SUNDRY NOTICES AND REPORTS ON WELLS

2. Name of Operator
Energy Acumen LLC

PLUG AND ABANDON WELLBORE
NEW MEXICO AK STATE 001
LEA COUNTY, NEW MEXICO
Class II

Action 378234

New Mexico AK State #001 Proposed WBD

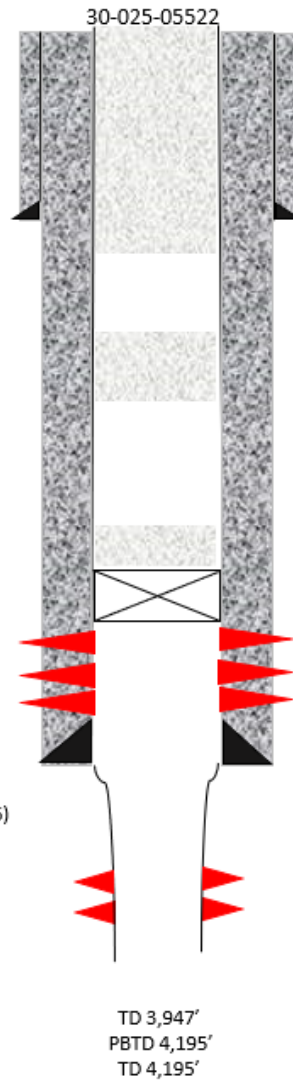
Created By	Condition	Condition Date
loren.diede	Notify NMOCD 24 hours prior to beginning P&A operations.	8/27/2024
loren.diede	Set CIBP @ 3550'. Load and roll hole, PT casing.	8/27/2024
loren.diede	Run CBL from CIBP at 3550' to surface. Submit CBL into NMOCD Imaging via E Permitting.	8/27/2024
loren.diede	Place cement plug from CIBP at 3550' to 3450'. WOC, tag plug to verify.	8/27/2024
loren.diede	P&A marker is to be an above ground marker. Submit marker photo and GPS coordinates with C-103P subsequent report.	8/27/2024
